RE: Lot 3 Block 4 Unit 19 Volcano Cliffs Subd.

6548 Azor Ln NW

RE: Lot 3 Block 4 Unit 19 Volcano Cliffs 6548 Azor Lane NW Grading and Drainage Plan Engineers Stamp Date 7/9/15 (D10D003T3)

Based upon the information provided in your submittal received 7/9/15, this plan cannot be approved for Grading Permit and Building Permit until the following comments are addressed.

Narrative

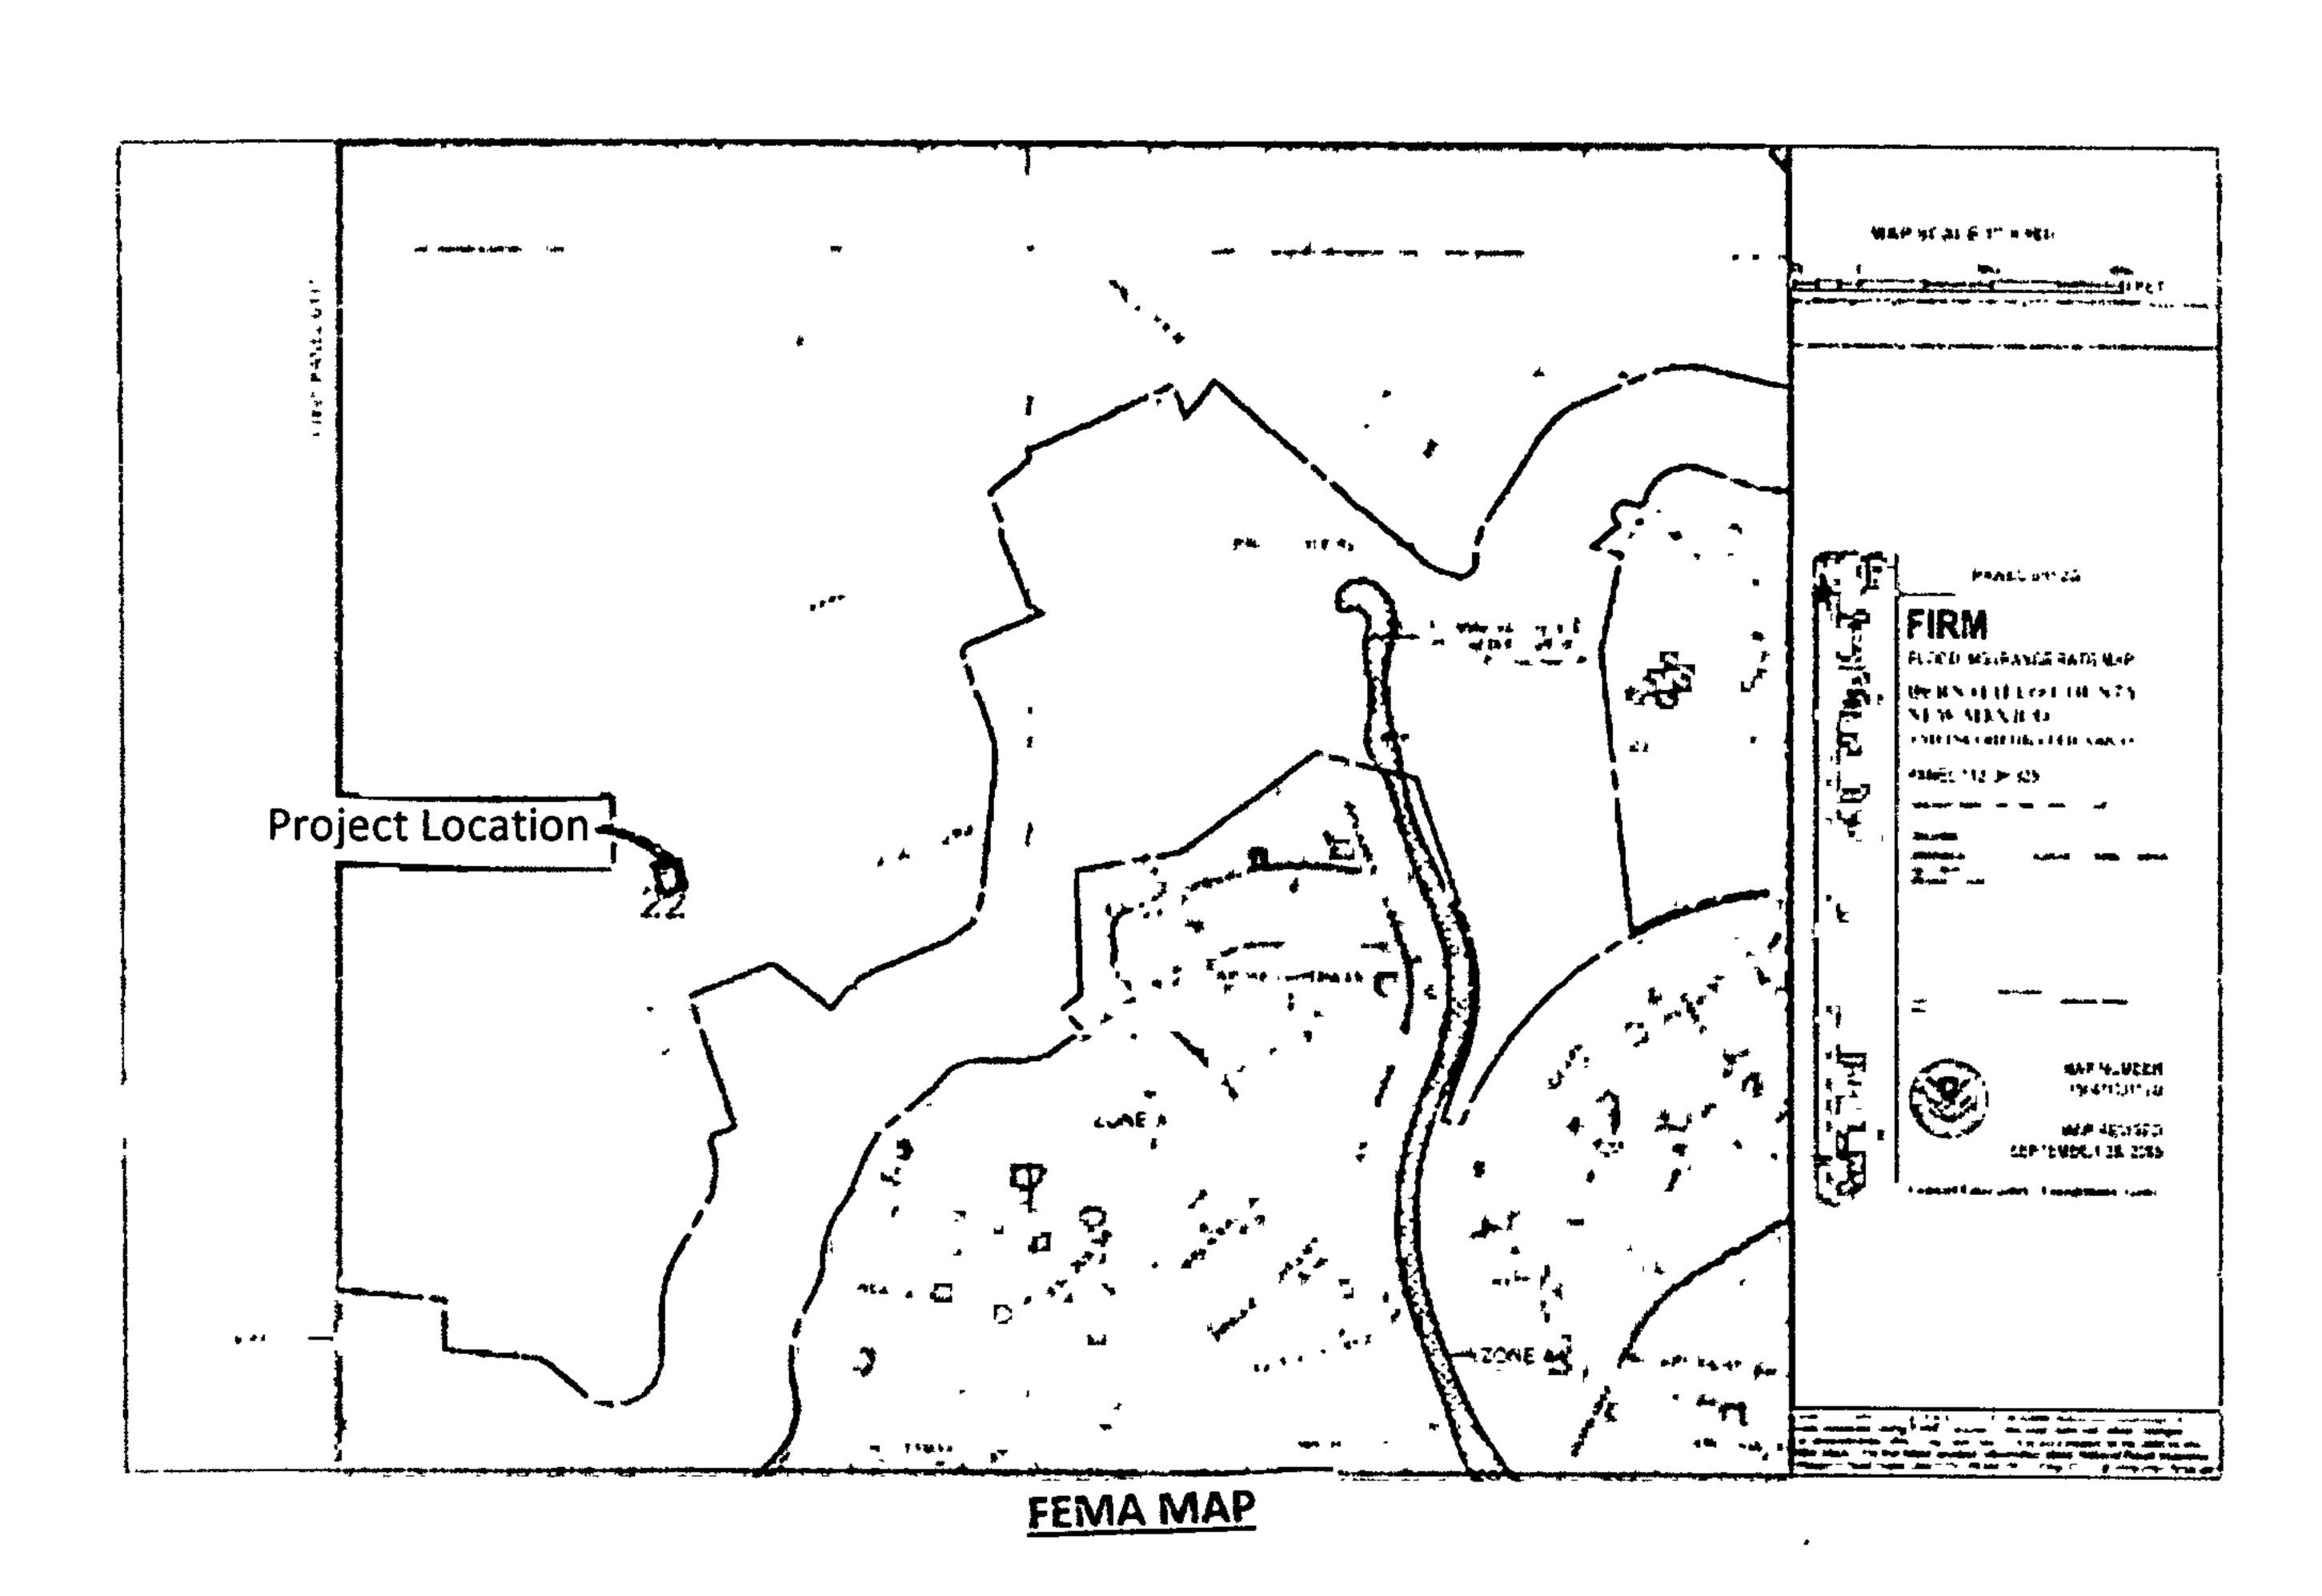
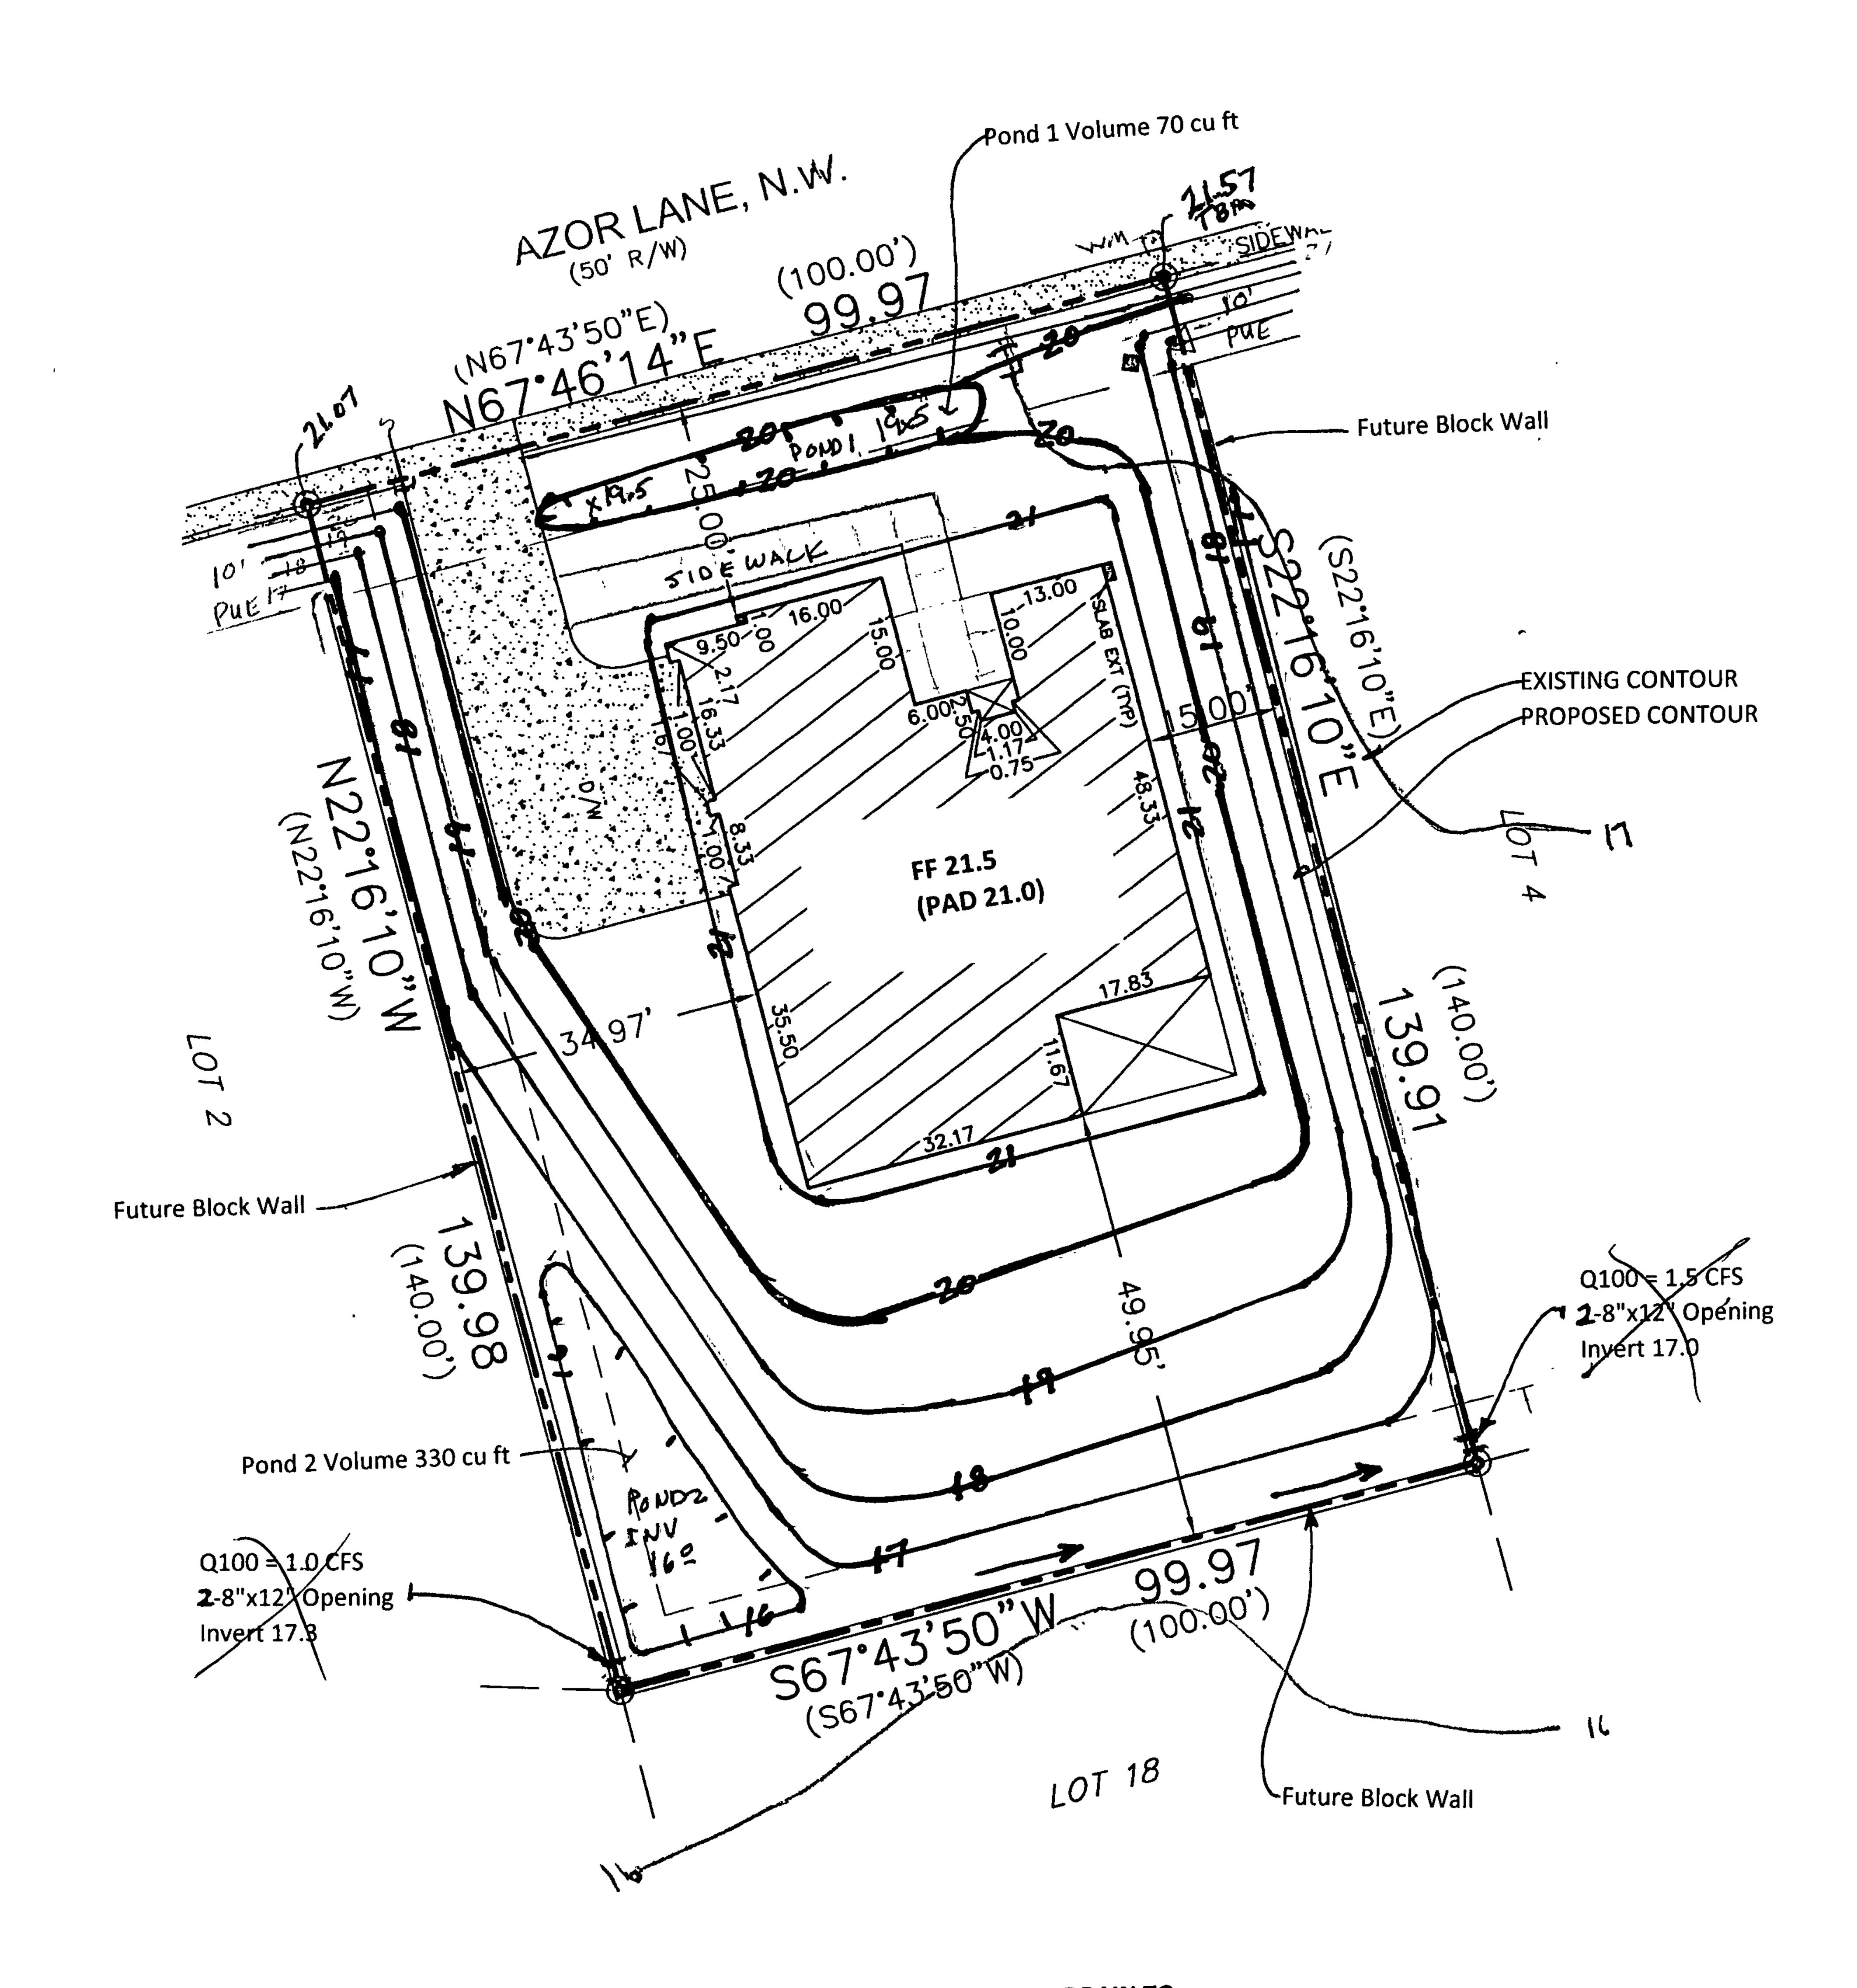
Based upon the information provided in your submittal received 7/9/15, this plan cannot be approved for Grading Permit and Building Permit until the following comments are addressed.

Provide flows for this property which exit out to Azor Street.

• Remove block openings.

• Provide swales from rear yard to front yard both sides of structure.
